Number	N.4
Section	Body and Exhaust System
Sheet	1 (of 1)
Date	May, 1960

PAINT COLOURS

BOOT LID LOCK

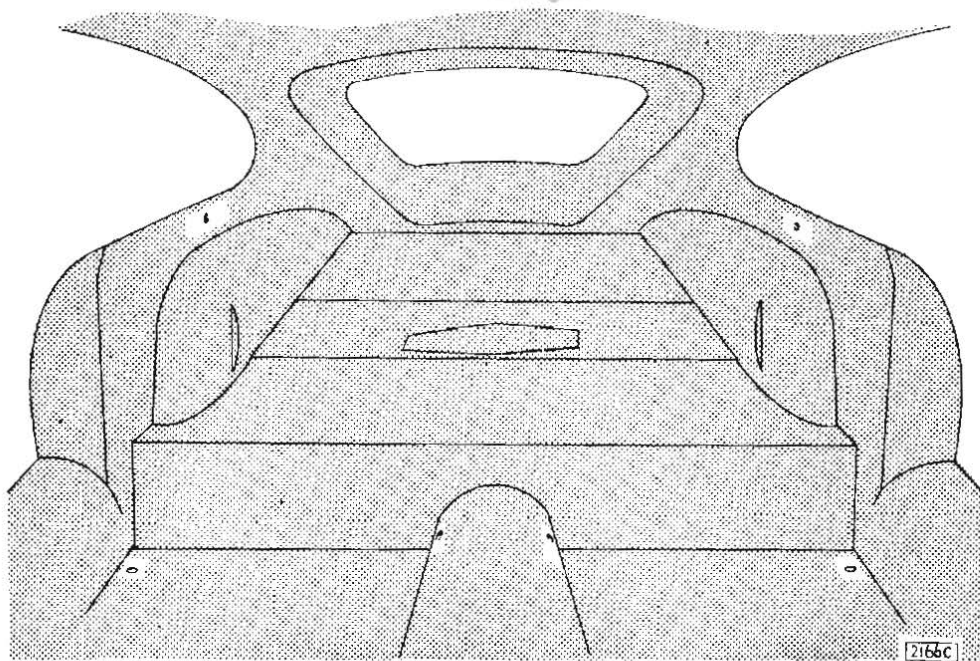
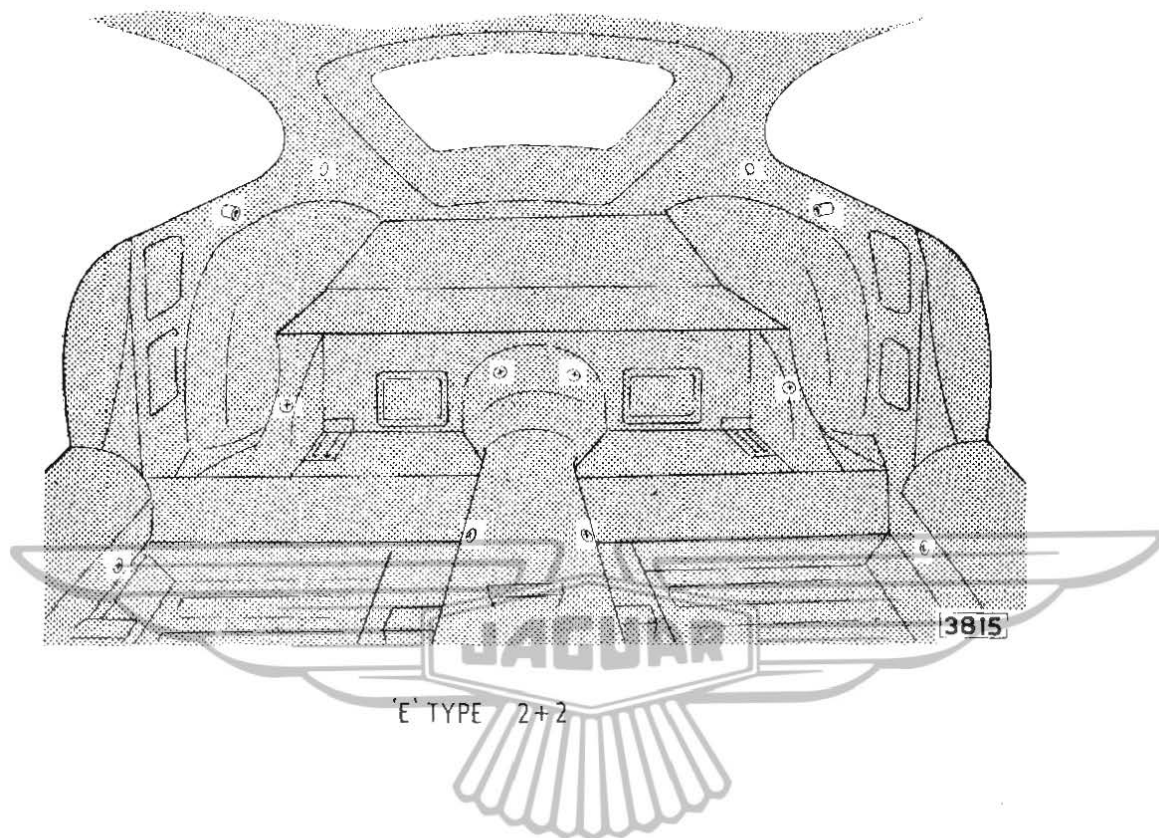
Commencing at the above chassis numbers an improved boot lid lock was fitted.

The lock incorporated a revised cam to prevent the boot lid from opening when on the road.

If complaints are received of the boot lid opening when the car is on the road, it is recommended that the new lock is fitted.

BONNET MASCOT

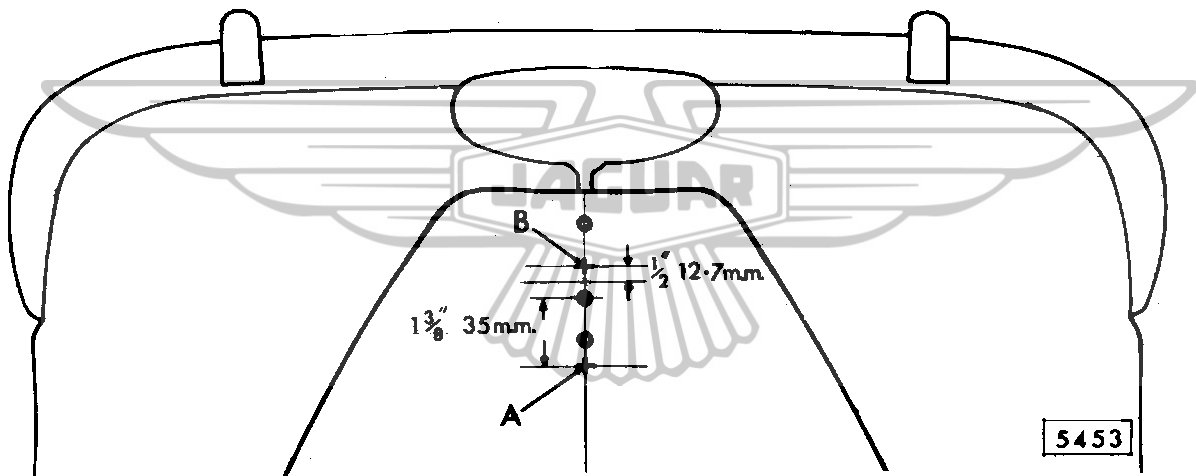
Difficulties in manufacturing Bonnet Mascot BD.10954 have resulted in it being withdrawn and supplies are no longer available. Orders for replacements for the above cars will therefore be executed by Jaguar Spares Division supplying an alternative Bonnet Mascot BD.29644 which varies from the original by the positions of the mounting studs. Instructions for the installation of the new Mascot are therefore detailed below.

1. Remove original Mascot from bonnet
2. Remove front and rear portion of bonnet centre beading
3. Retouch paintwork (if necessary) where bonnet is affected by contact with Mascot or chrome beading.
4. Lightly mark centre line through existing fixing holes, extending line forward by 2 in. (50 mm.).
5. Drill 3/16 in. (4.8 mm.) hole 'A' on centre line, 1 3/8 in. (35 mm.) to rear of front Mascot fixing hole. Locate new Mascot in holes
6. Place rear chrome bead in position, mark against rear of new Mascot base. Remove chrome bead and carefully cut to length. Clean up end of bead.
7. Place front chrome bead in position, mark against front of new Mascot base. Remove chrome bead and carefully cut to length. Clean up end of bead.

8. Lightly mark bonnet across front of new Mascot base.
9. Remove Mascot and centre pop bonnet $\frac{1}{2}$ in. (12.7 mm.) forward of mark. Drill $\frac{1}{8}$ in. (3.17 mm.) diameter hole 'B' in bonnet.
10. Locate clip BD.11719 and secure to bonnet, using pop rivet BD.1814/6
11. Fit Mascot and secure to bonnet, using special cup washer, part number 1744 at front fixing, nuts UCN.119/2 and shake-proof washers C.723/A
12. Fit modified front and rear chrome beads.
